ADDENDUM No. 1

Project Name:	Owner: City of Dexter Project Name: Dexter City Hall Renovations	Addendum No: One (1)
Project Number:	21-113	Issue Date: January 21, 2022
Project Location:	3515 Broad St. Dexter, Michigan 48130

A3-10

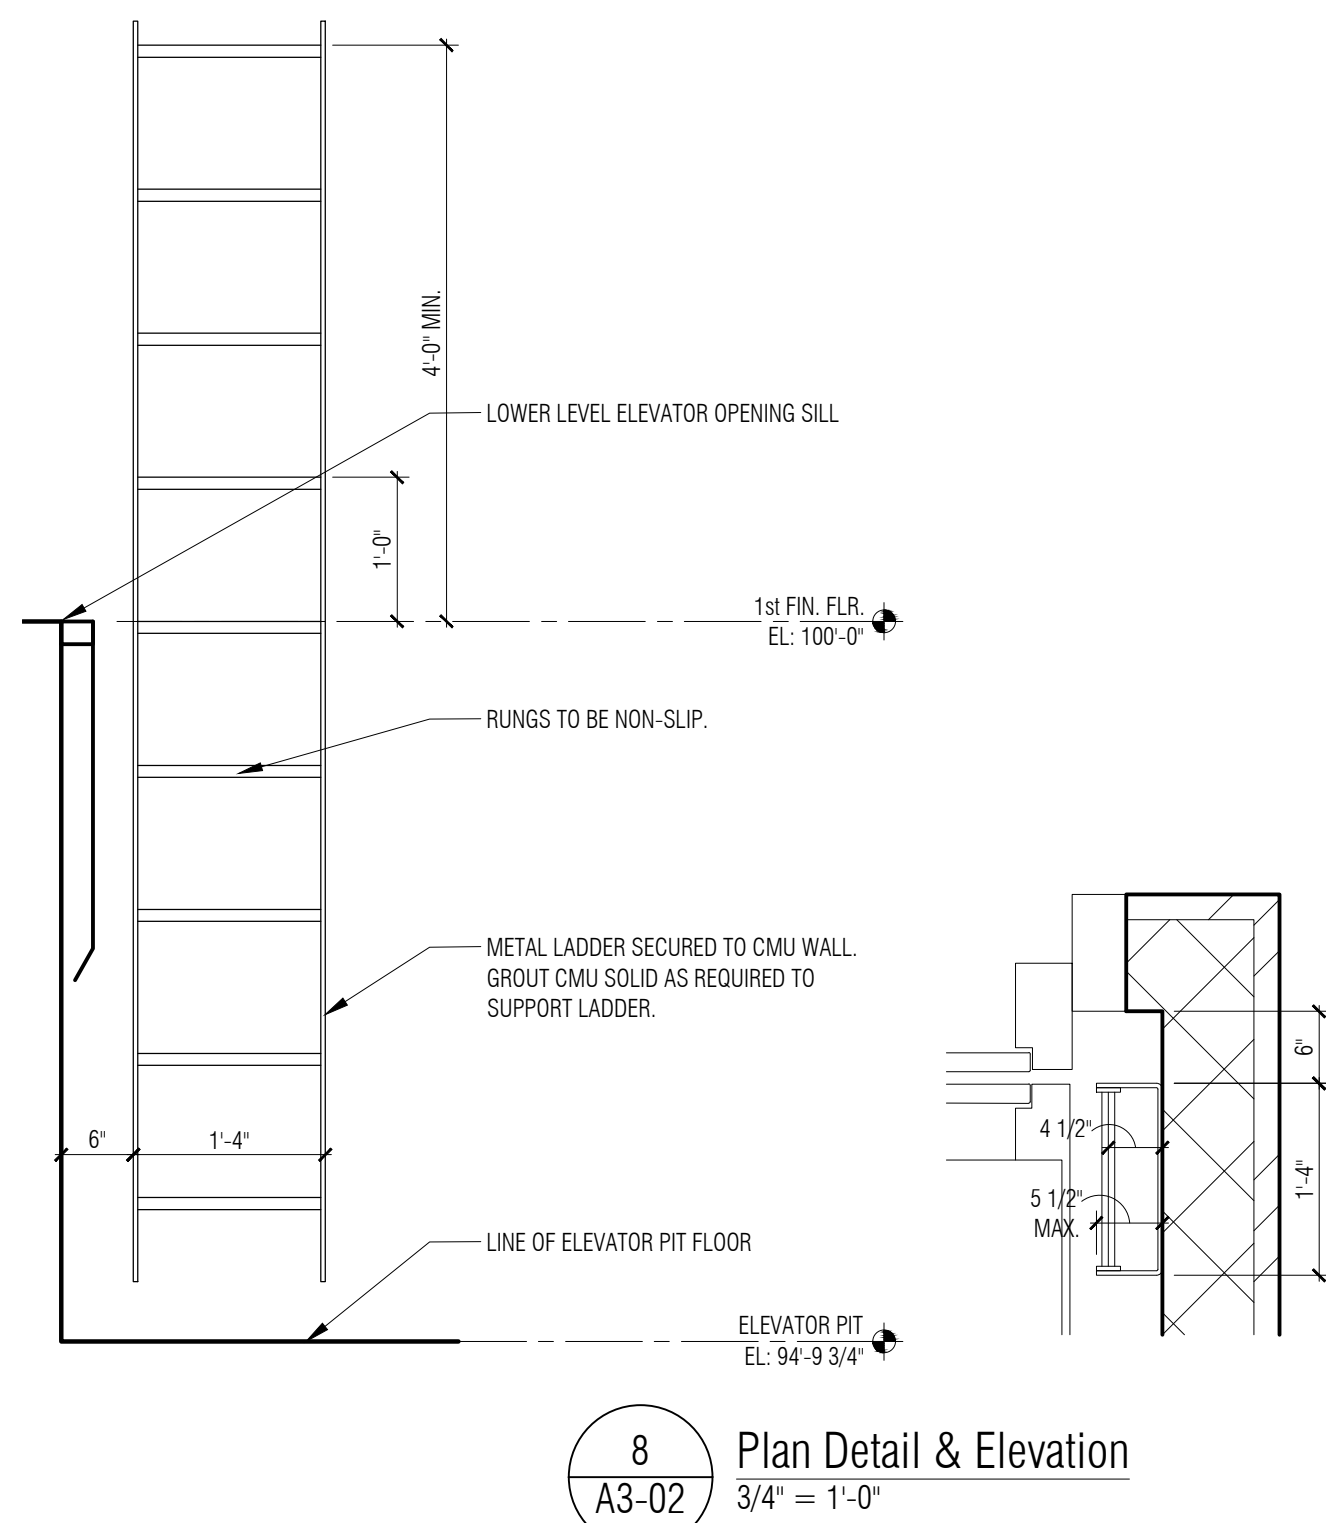
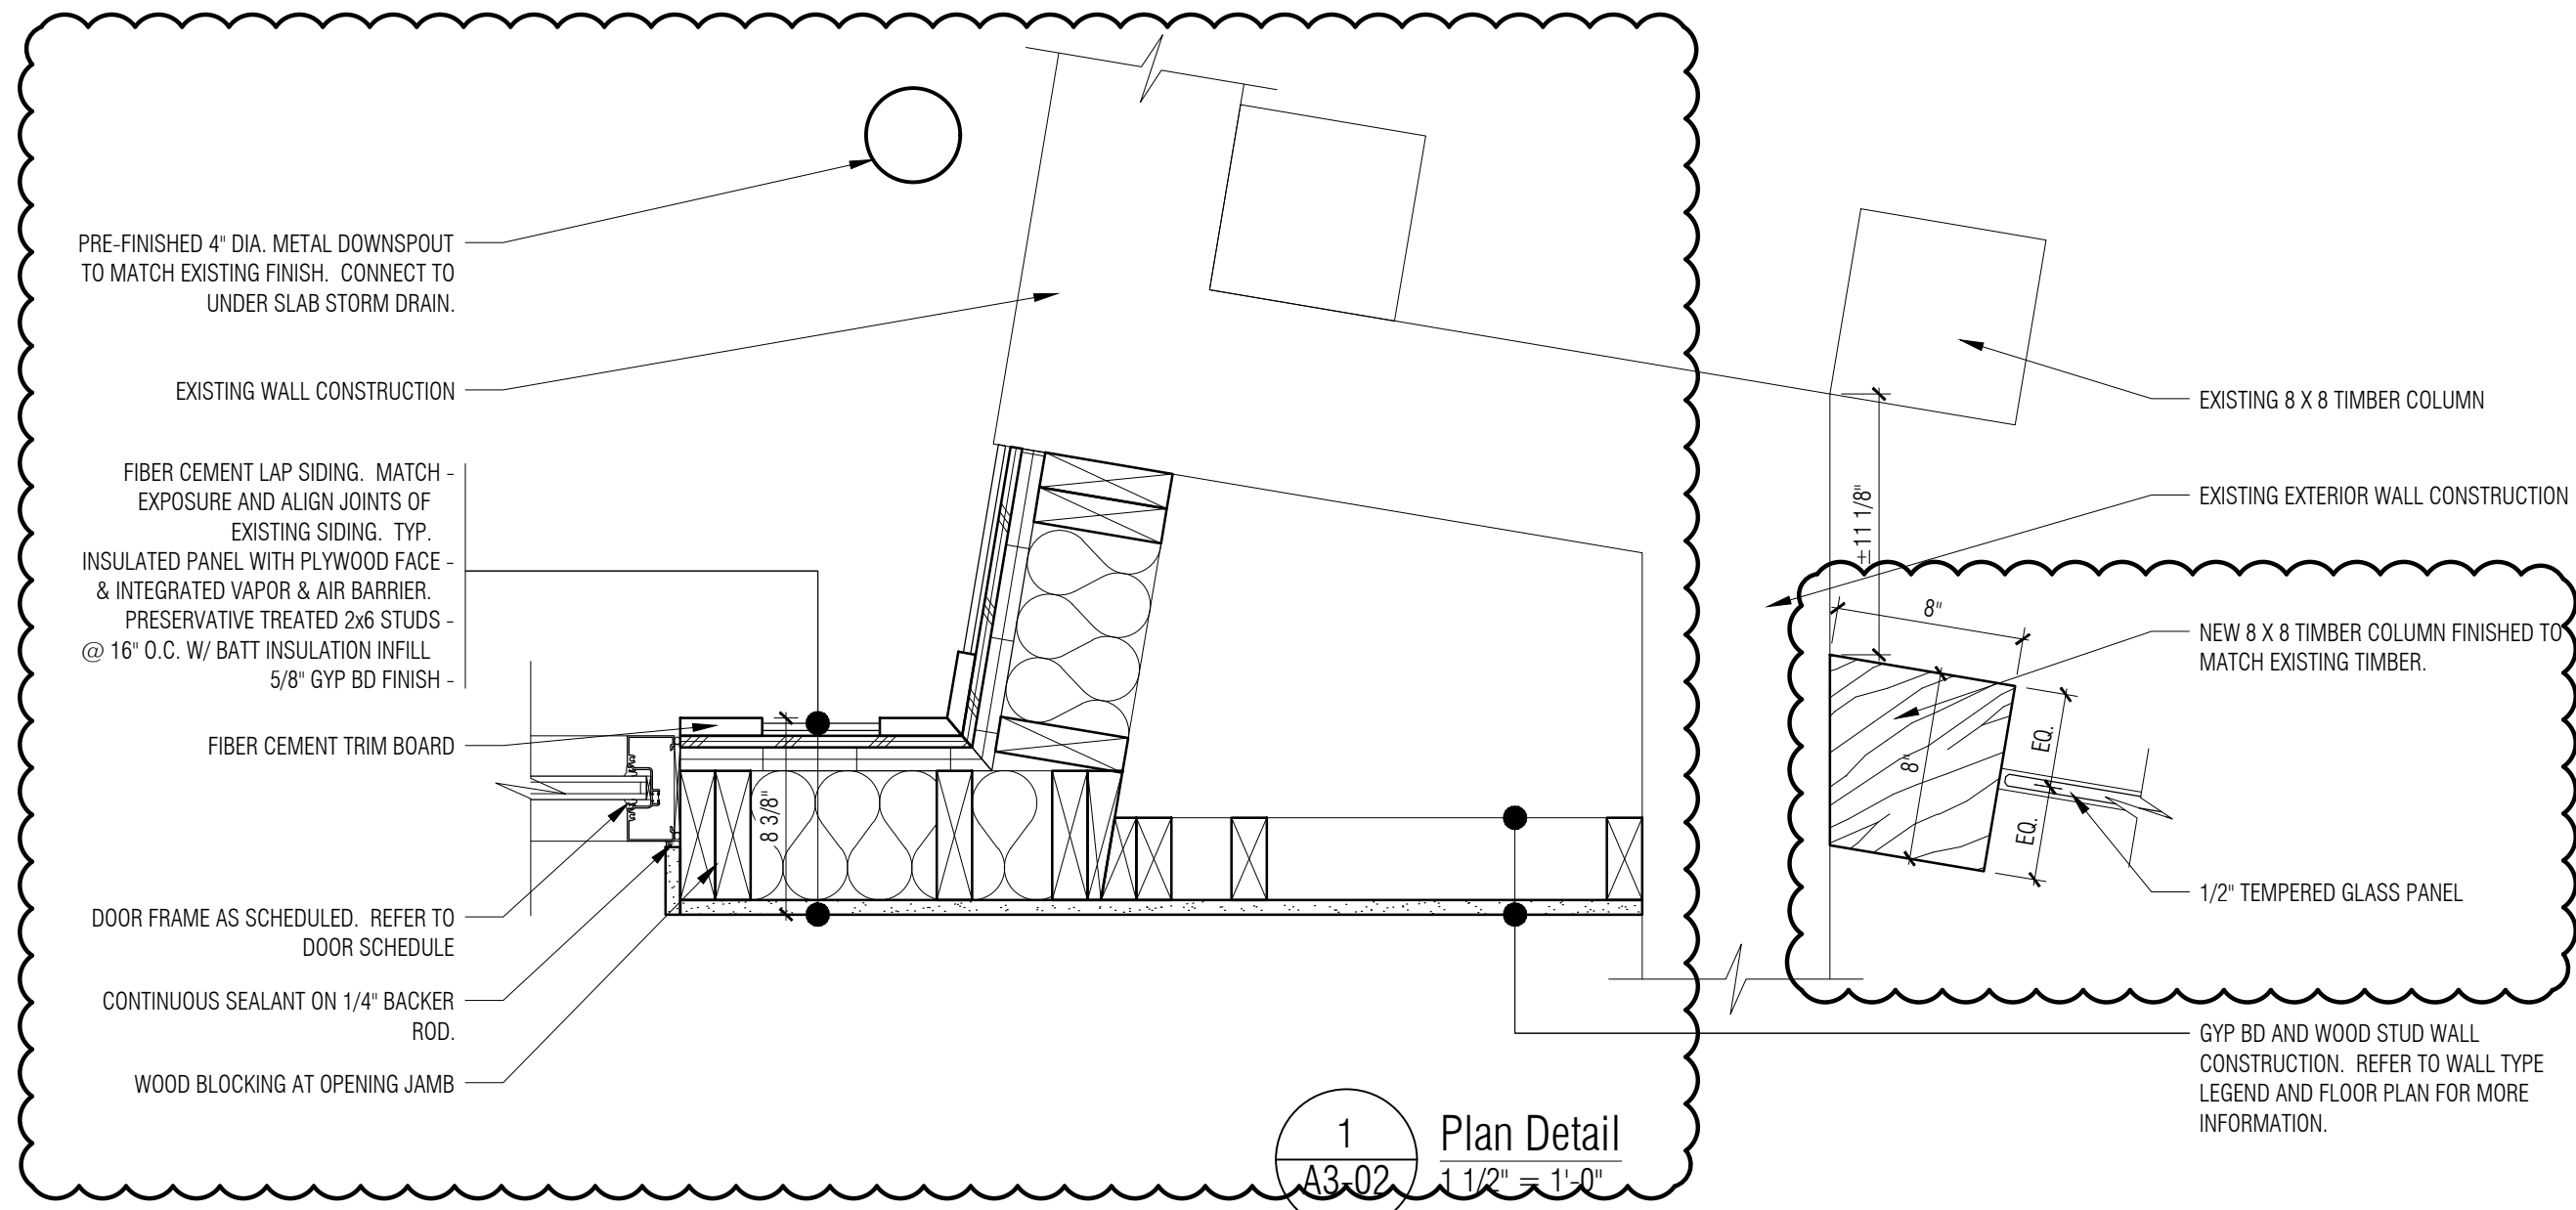
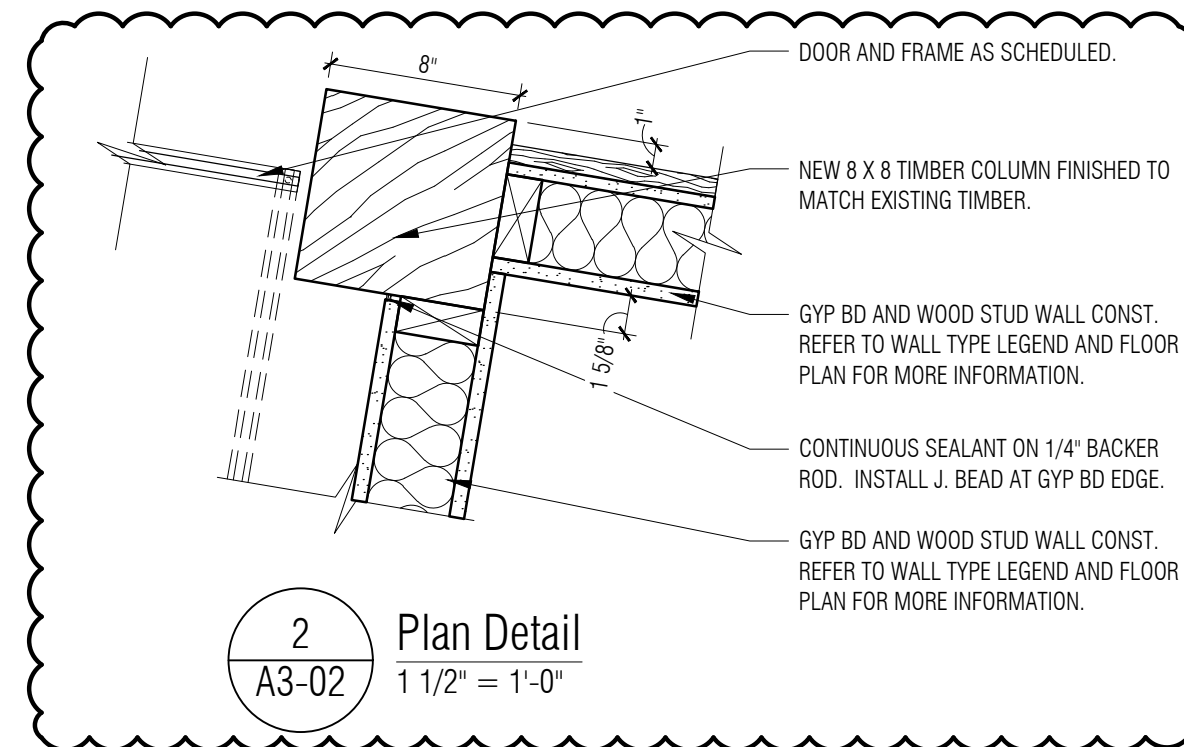
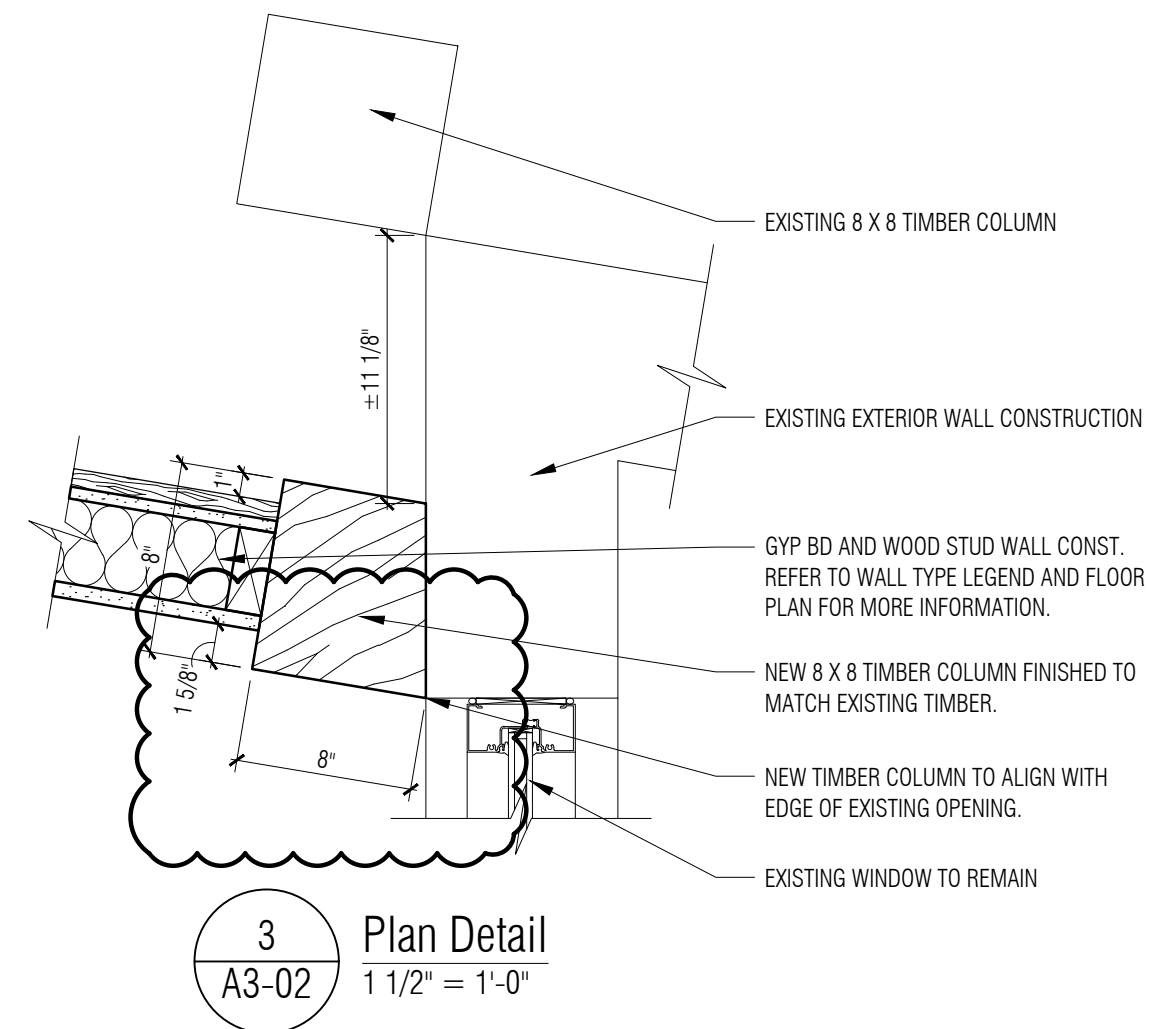
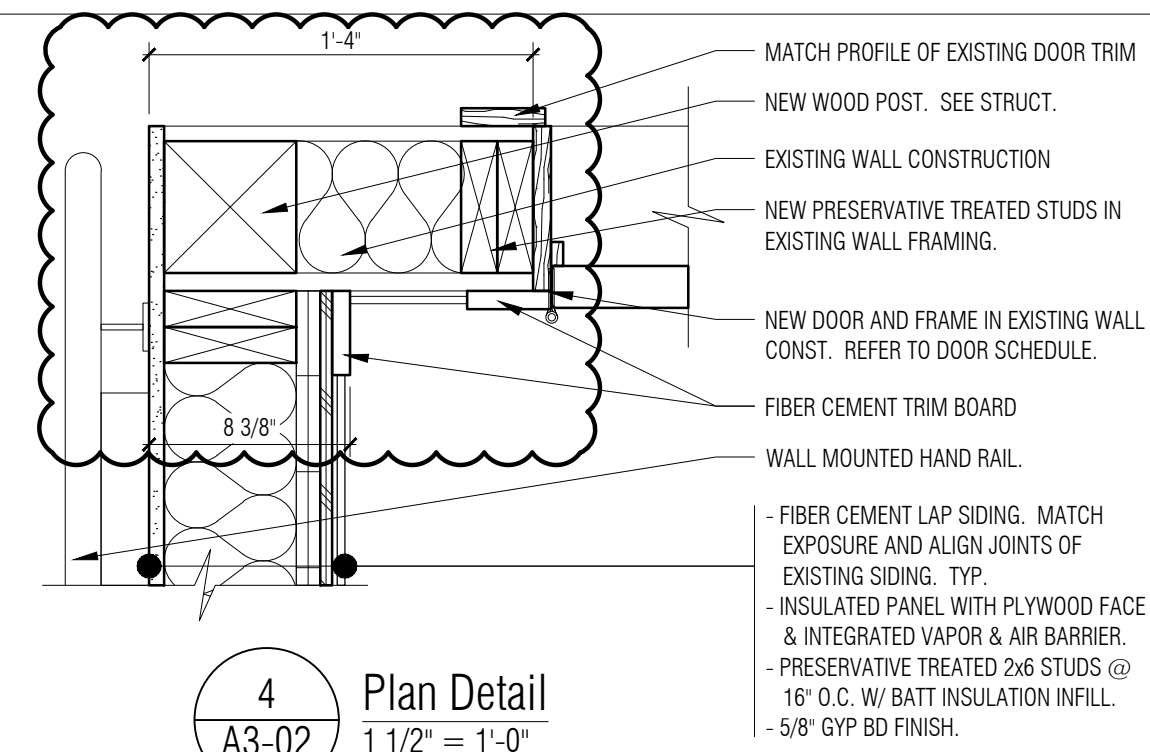
- A. Updated detail 1 to remove batt insulation @ interior wall, added callout for downspout, and updated door / sidelight layout to match plan updates.
- B. Updated detail 2 to show gyp bd covering southeast corner of timber column, and updated door / sidelight layout to match plan updates.
- C. Updated detail 4 to add clarifying dimension.
- D. Updated detail 7 to show tension cable guard system, rather than steel posts.

A3-22

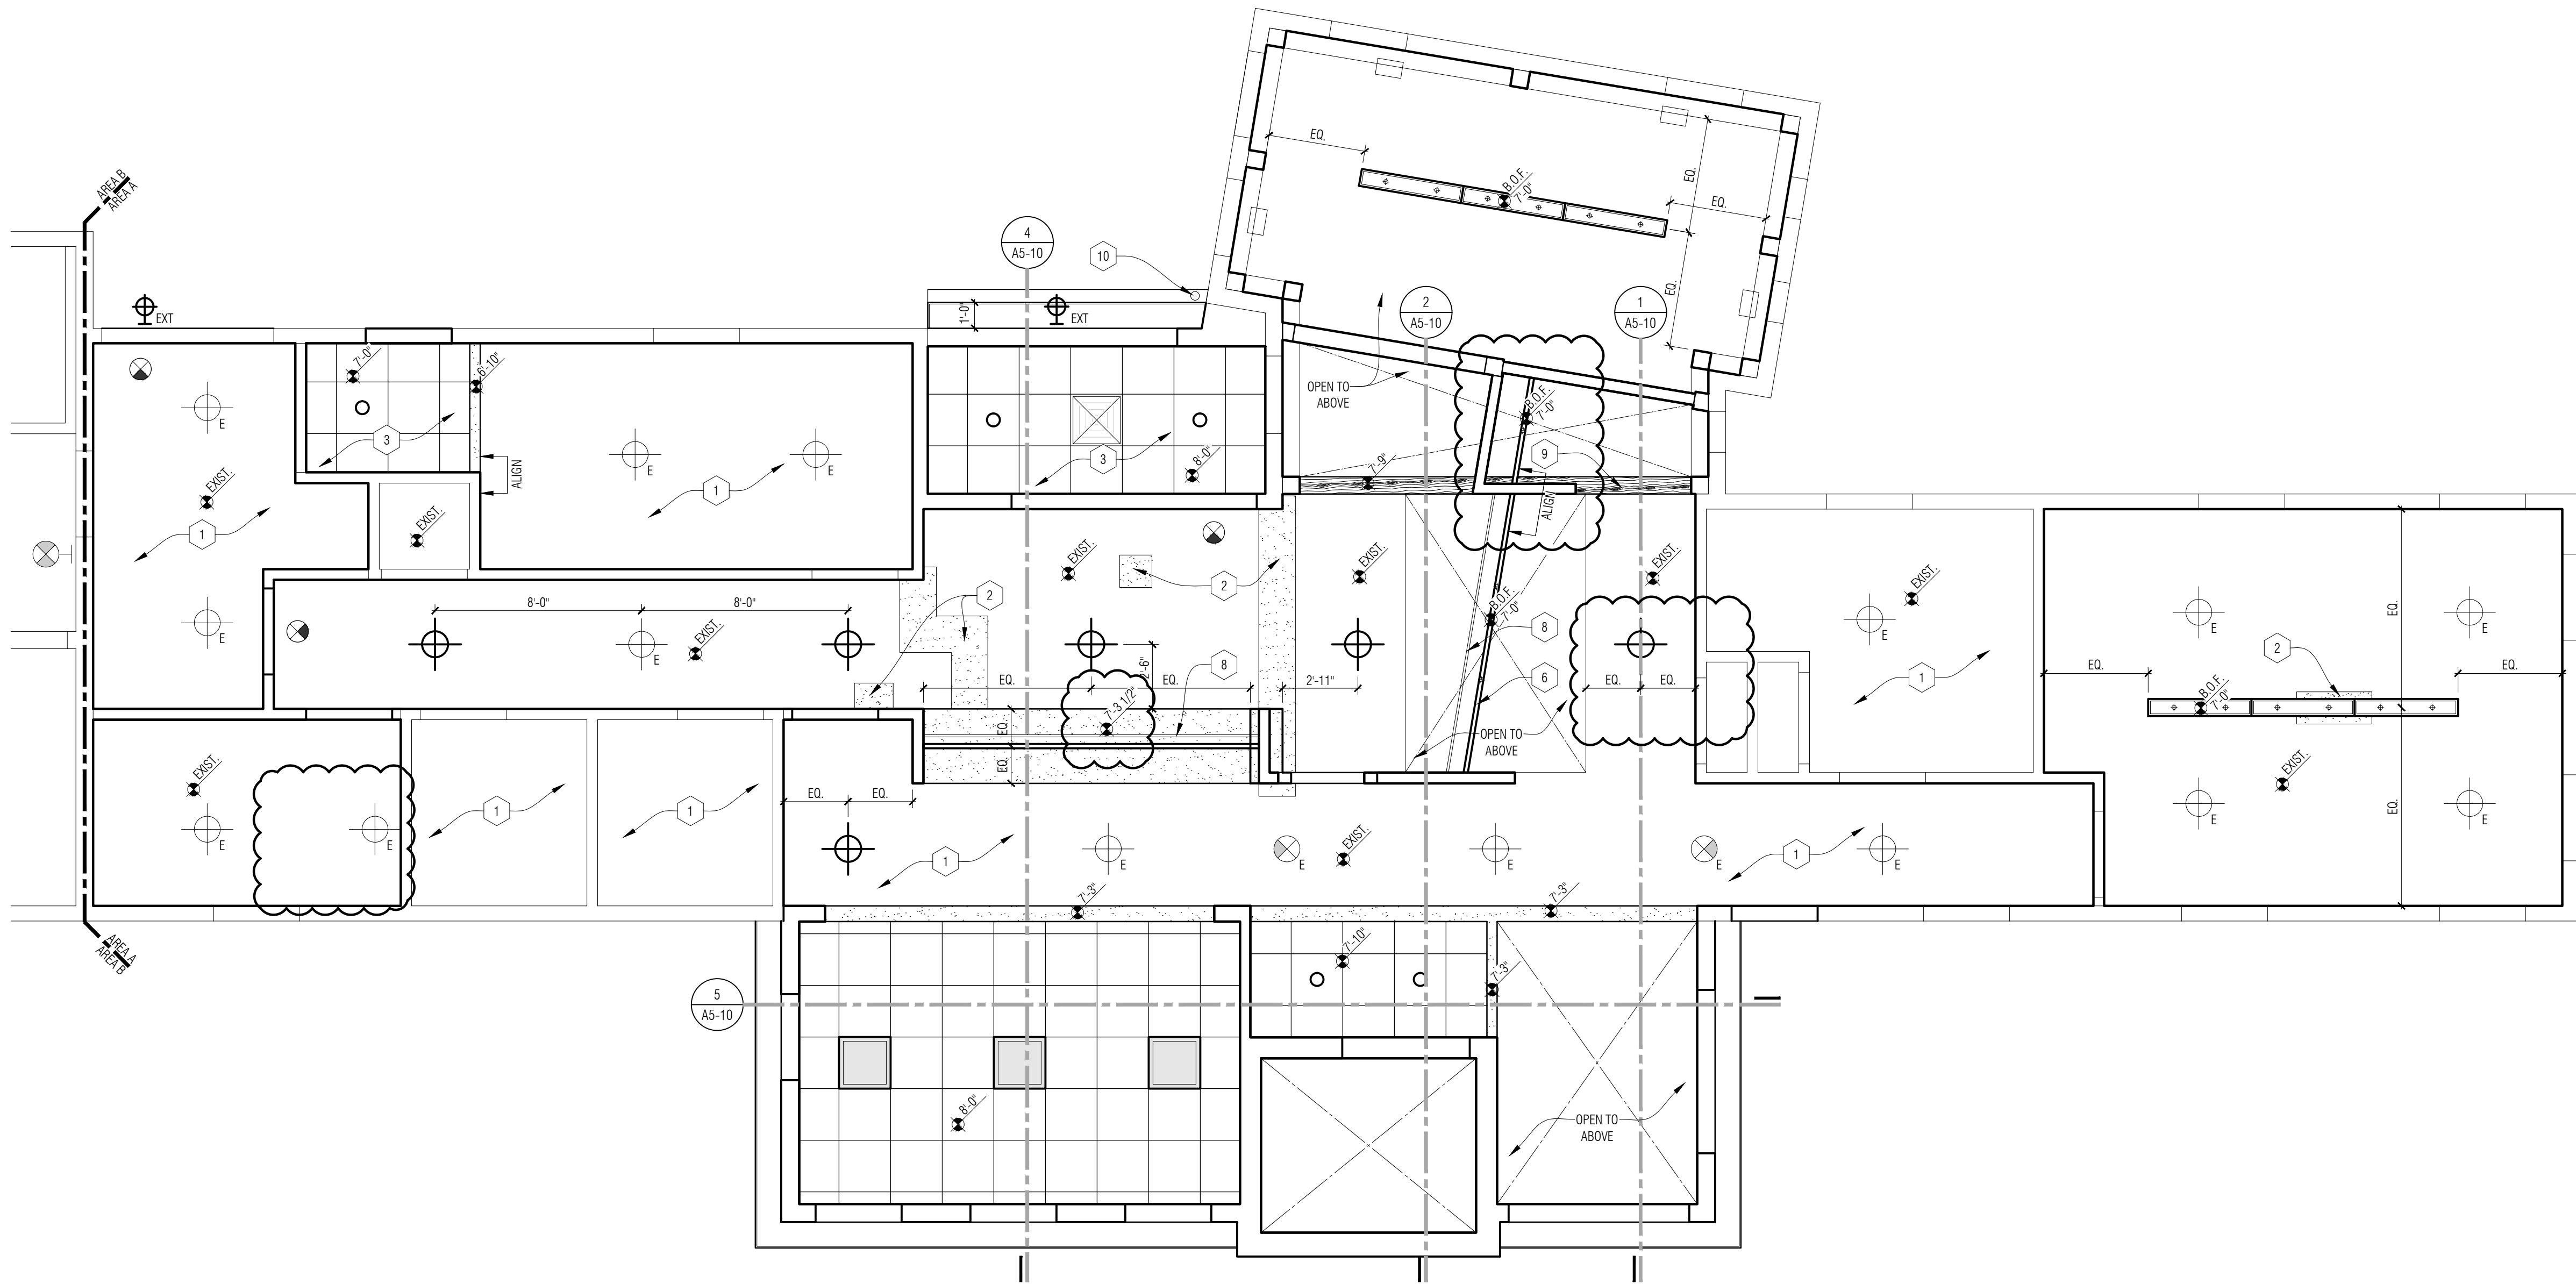
- A. Updated building section tag near vestibule to read detail 4, rather than 3.
- B. Added building section tag through Reception 111, Elev Lobby 109, and stairs to match floor plan sheets.
- C. Added callout for ridge cap at elevator, and associated keynote 8.
